Port Licence Amendment Application, Q3 2025

Rev 0	Document # OP-APP-00016	Author B. Charnley	Author Title Graduate Environment	Approver M Agostini	Approver Title Head of Risk and Compliance	Issue Date 09/09/2025
----------	----------------------------	-----------------------	---	------------------------	--	--------------------------

Figure 2 HIO port prescribed premise boundary

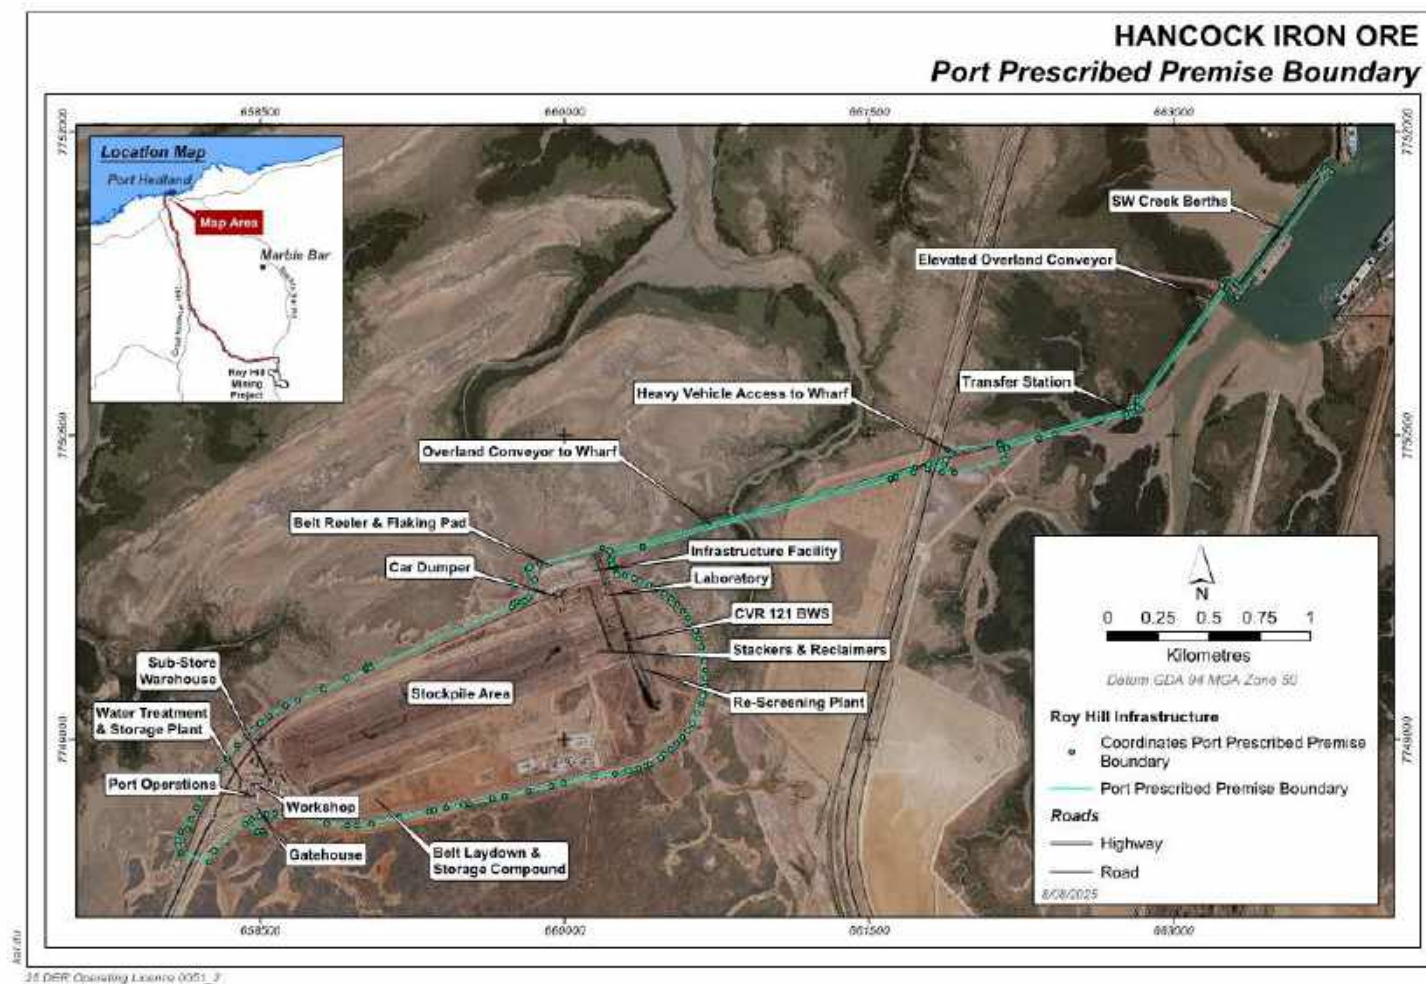
The following updated figures are requested to replace the existing figures in the Licence:

Figure Reference in Approved Licence	Figure Reference in this Document	Reason for Update
Figure 1	Figure 2	Including constructed BWS within figure
Figure 4	Figure 3	Removal of rehab trial locations & update figure caption to show discharge locations

Figure 4 – Port (fines and lump) Throughput and DM2-6 PM10 (2020 to 2025)

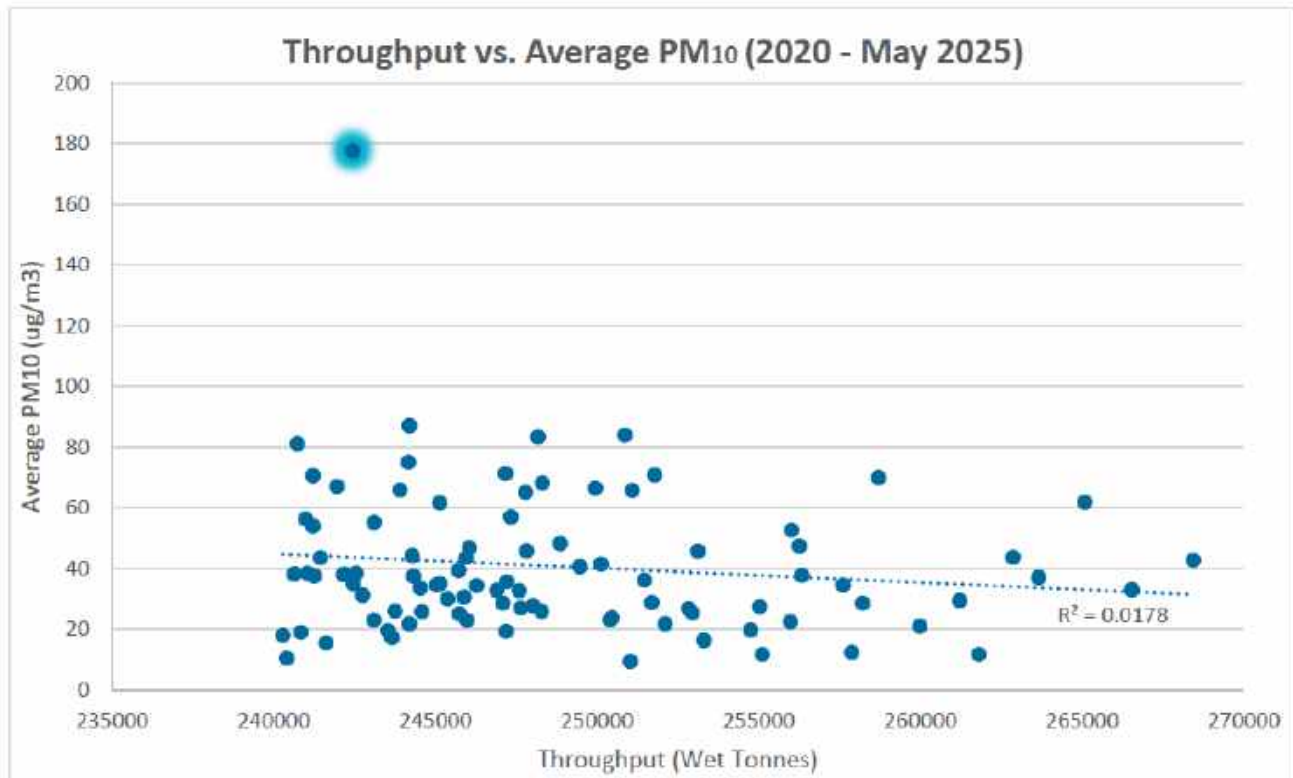
Figure 4 indicates a general view of measured PM10 (ug/m3) averaged across the five downwind boundary monitors for the days throughput exceeded the daily threshold of 240,000 wet tonnes.
